**PREPARED FOR THE BOARD OF COMMISSIONERS OF PUBLIC UTILITIES OF
NEWFOUNDLAND AND LABRADOR**

In response to Newfoundland Labrador
Hydro's 2025 "Application for Capital
Expenditures for the Purchase and Installation
of Bay d'Espoir Unit 8 and Avalon
Combustion Turbine"

EXPERT ADDENDUM REPORT OF VINCENT MUSCO AND COLLIN CAIN

November 6, 2025

Figure 1: Average peak generation as percentage of maximum generation capacity during the LIL outage period

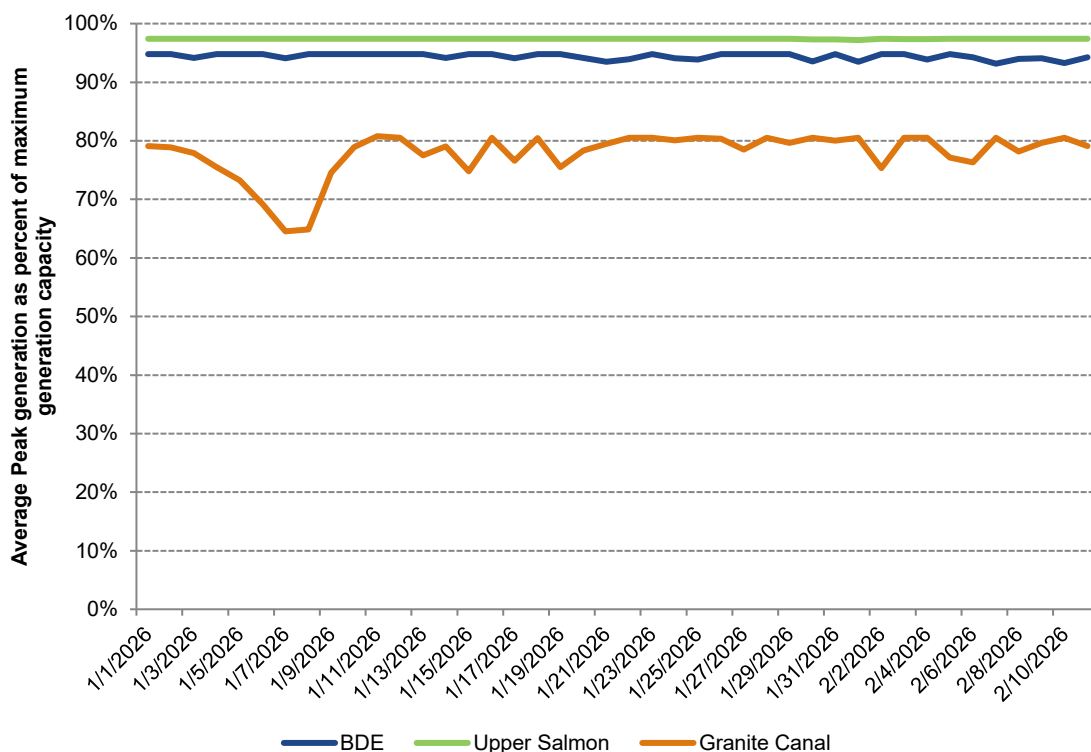
- (55) These results do appear to be conditioned on certain assumptions made by Hydro and inputted into the modeling presented in the October 2025 Vista Study. First, the modeling assumed that Long Pond would enter the six-week LIL bipole outage with hydrological capacity equal to 92% of its maximum operating level.¹³⁶ Hydro explained that its “normal target range for the Long Pond Reservoir in preparation for winter is 90-92% of maximum operating level,” though “operational decisions are at all times a balance of cost and reliability.”¹³⁷ Hydro further notes that due to the planned retirement of Holyrood TGS and the addition of an eighth unit at BDE, Hydro will pursue the 90-92% target storage range for Long Pond “more aggressively than in the past.”¹³⁸ Lower storage levels than assumed at Long Pond (and at Meelpaeg and Victoria) could increase the risk of hydrological shortages in the BDE system either during a six-week LIL bipole outage or in the aftermath of such an event.

Figure 2: Long Pond Inflows (October 2025 Vista Study, January 1 through March 31)¹⁴⁰

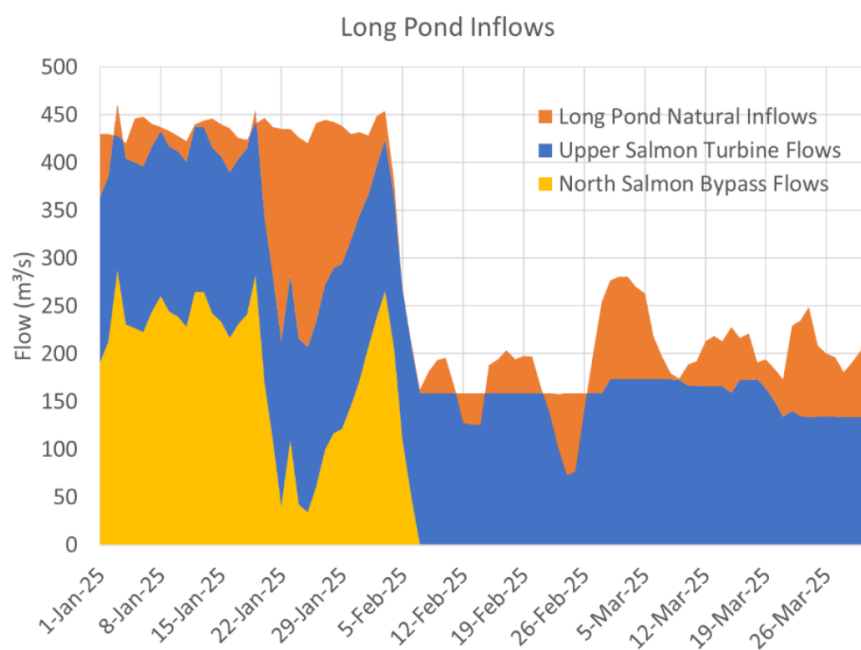
insufficient to sustain the modeled level of output from BDE Units 1-8. Moreover, the modeled inflows for Long Pond during the winter were determined by selecting actual data from a prior year (2019) that “corresponded” to P50 values, but were not determined through a statistical approach that takes P50 values for each day based on historical data.¹³⁹ This approach impacts the results, as the model in the October 2025 Vista Study included large natural inflow events to Long Pond in the late January 2019 period. Figure 2 below shows the three sources of inflows to Long Pond: natural inflows (in orange), inflows from the Upper Salmon turbine (blue), and inflows from the North Salmon Bypass spillway (yellow). The late January high natural inflow event can be seen in the figure, where natural inflows displace Upper Salmon and North Salmon Bypass inflows in the middle of the outage period.

- (57) Hydro notes that the natural inflows shown in Figure 2 above come from actual data in 2019, including data from January 21, 2019, when an average daily temperature of +4.9 degrees Celsius and precipitation of 75 mm was recorded at the Long Pond intake station.¹⁴¹ The selection of 2019 data to simulate Long Pond inflows is advantageous in this case. And given that the assumed Long Pond inflows correspond to a P50 confidence level compared to historical data, there is a 50% chance that actual inflows would be lower than what is assumed, potentially increasing the risk of hydrological

Figure 3: BDE Hydrology Map (partial view)¹⁴⁵

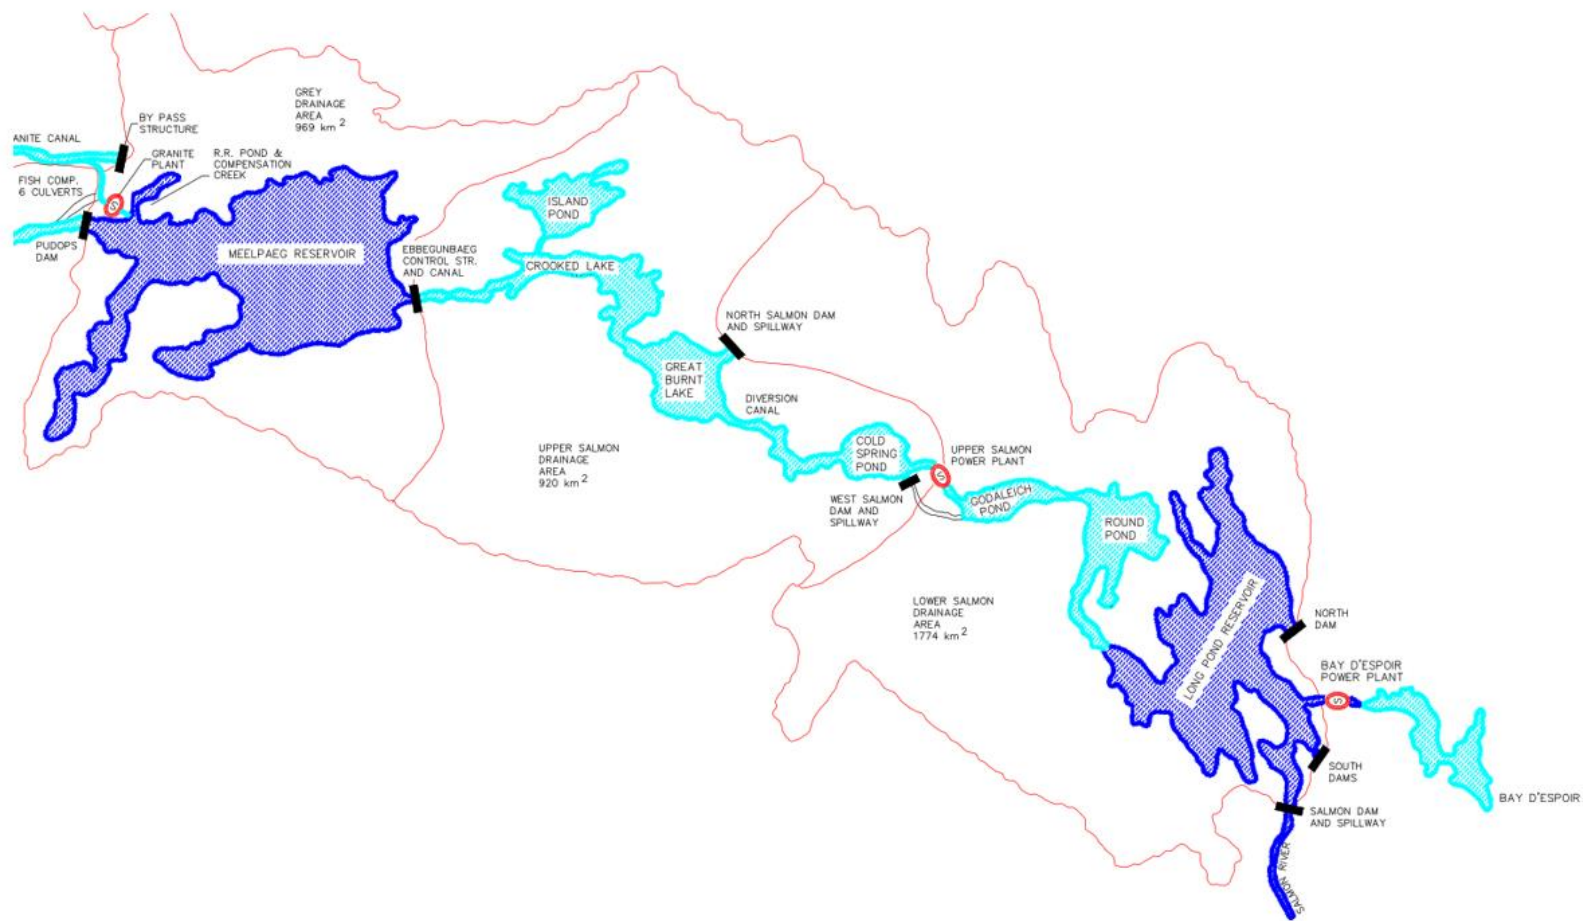
- (59) Specifically, the model results in the October 2025 Vista Study show that 592 MCM of water is spilled over the North Salmon Bypass spillway to Long Pond, representing about 41% of all inflows to Long Pond during the modeling period.¹⁴³ This is a large amount of spill activity and is in fact nearly equal to the assumed inflows from the Upper Salmon generating turbine to Long Pond during this period (614 MCM, or 43% of all inflows).¹⁴⁴ Figure 3 below shows a portion of the BDE hydrological system, including Meelpaeg and Long Pond Reservoirs, the Upper Salmon and BDE power plants, and the North Salmon Bypass spillway.
